Subject: CESSAR and Palo Verde SER Confirmatory Items

Transmitted herewith is Combustion Engineering input which is intended to close out the following confirmatory items identified in Section 1.8 of the CESSAR Safety Evaluation Report (SER):

Each enclosure contains revised CESSAR Final Safety Analysis Report (CESSAR-F) Round One question responses and marked-up CESSAR-F text pages. These marked-up changes will be incorporated into the next amendment of CESSAR-F.

The final enclosed item was not an SER confirmatory item, but is being submitted to reflect a design change as a result of NRC review:

Figure
9.3-1

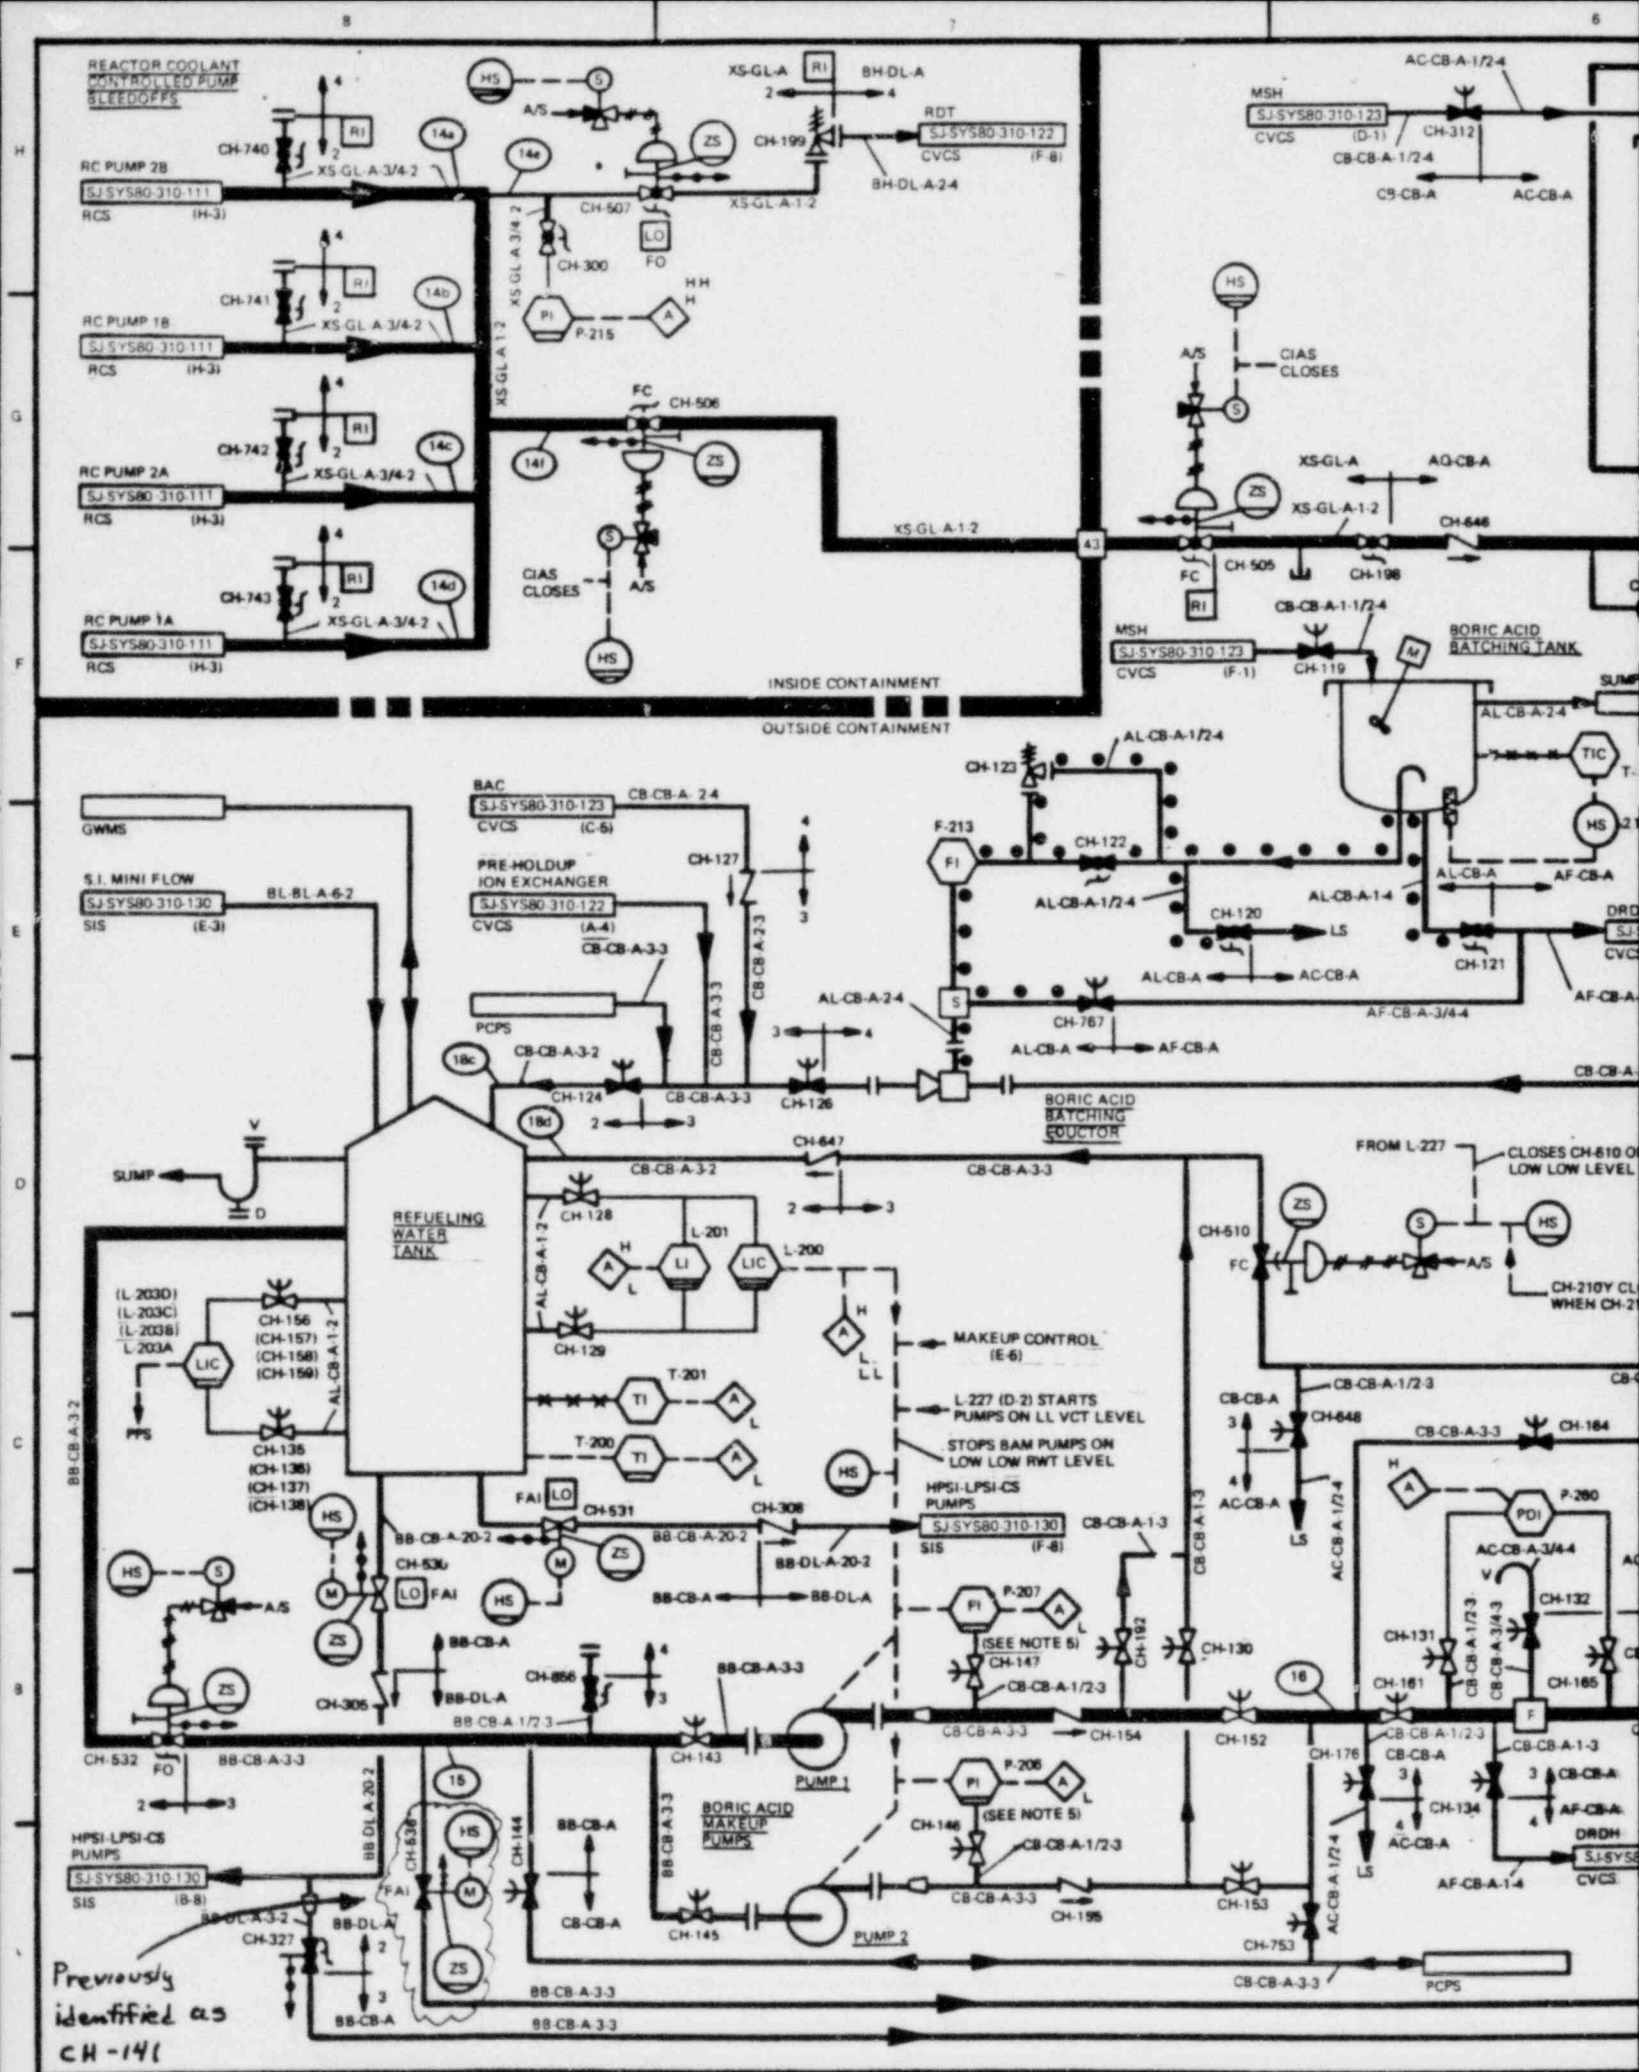
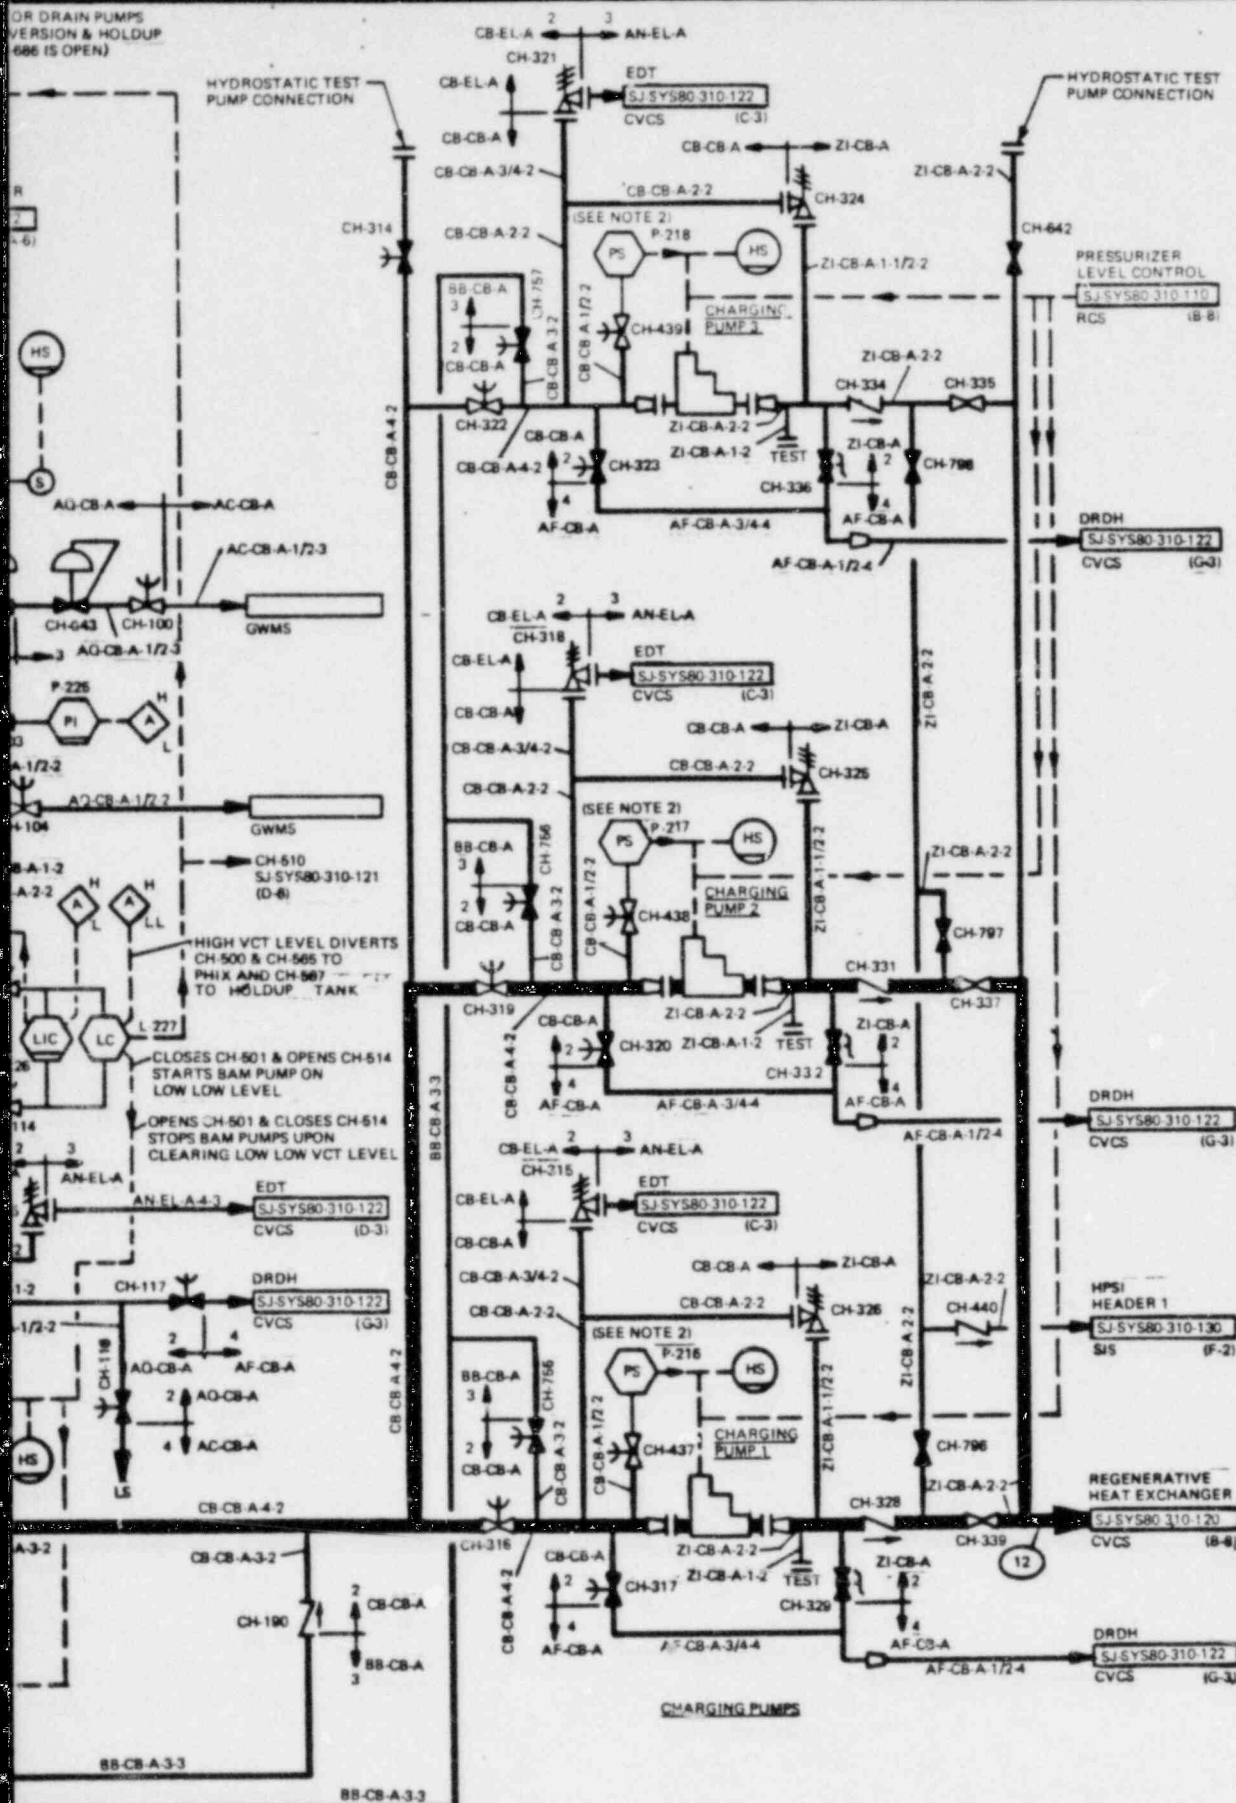
Redundant safety grade gravity-feed suction lines from the refueling water tank to the charging pumps can be made available upon realignment of valve CH-501 from the control room. One pathway is provided by opening valve CH-536 from the control room while the other pathway requires manual realignment of valves CH-327, 755,756, and 757 from outside of the control room. Valves CH-501 and CH-536 are operable from an emergency onsite power source.

The safety grade charging pump discharge line remains aligned to the RCS following a loss of offsite power. Although charging isolation valve CH-240 fails to a closed position during a loss of offsite power, spring check valve CH-435 provides a parallel flow path to the RCS loop charging nozzles. When the auxiliary spray isolation valves are closed, the spring check valve will lift, allowing charging flow to bypass the charging isolation valve. An alternate charging delivery path can be established through the HPSI header. Manual operator actions to realign valves CH-796, 797, 798 and SI-508 are required to establish this backup delivery path.

FIGURE 7.7-10

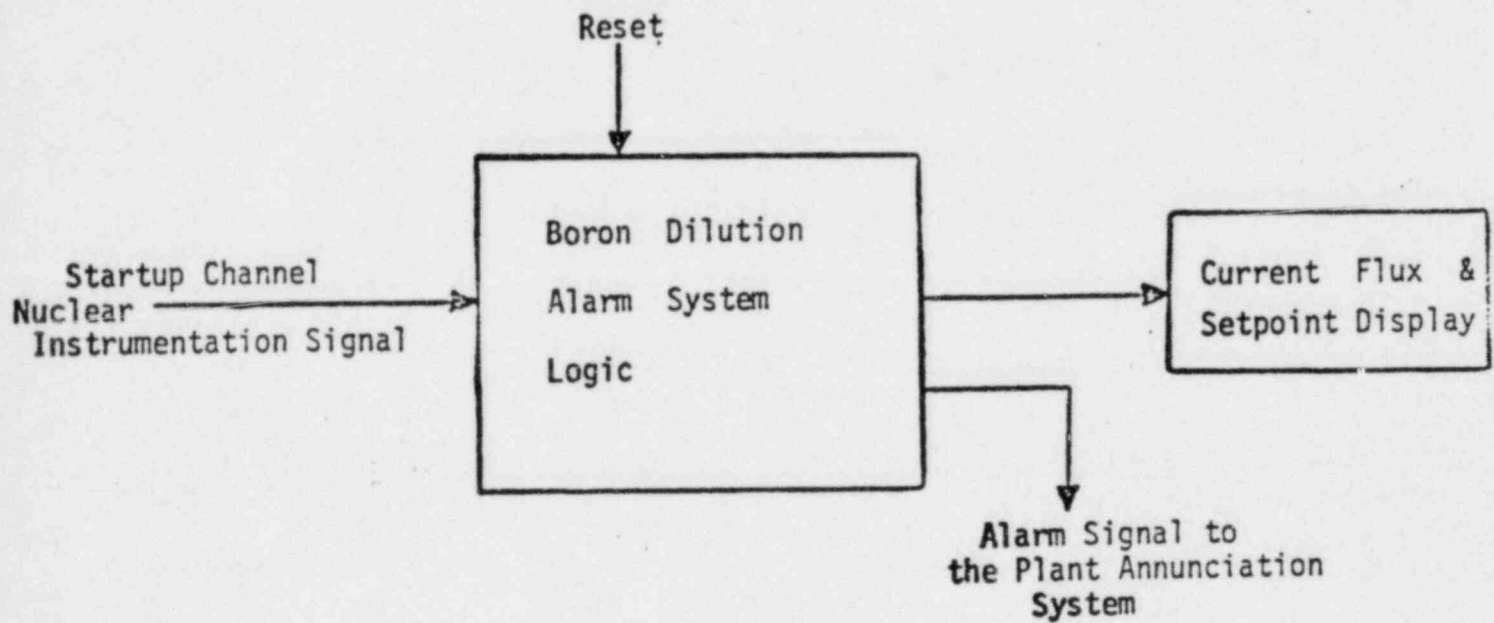
Reactivity control in the reactor core is effected, in part, by soluble boron in reactor coolant system. The Boron Dilution Alarm System (Figure 7.7-10) utilizes the startup channel nuclear instrumentation signals to detect a possible inadvertent boron dilution event while in Modes 3-6. There are two redundant and independent channels in the Boron Dilution Alarm System (BDAS) to ensure detection and alarming of the event.

The BDAS contains logic which will detect a possible inadvertent boron dilution event by monitoring the startup channel neutron flux indications. When these neutron flux signals increase (during shutdown) to equal or greater than the calculated alarm setpoint, alarm signals are initiated to the Plant Annunciation System. The alarm setpoint is periodically, automatically lowered to be a fixed amount above the current neutron flux signal. The alarm setpoint will only follow decreasing or steady flux levels, not an increasing signal. The current neutron flux indication and alarm setpoint (per channel) are displayed. There is also a reset capability to allow the operator to acknowledge the alarm and initialize the system.
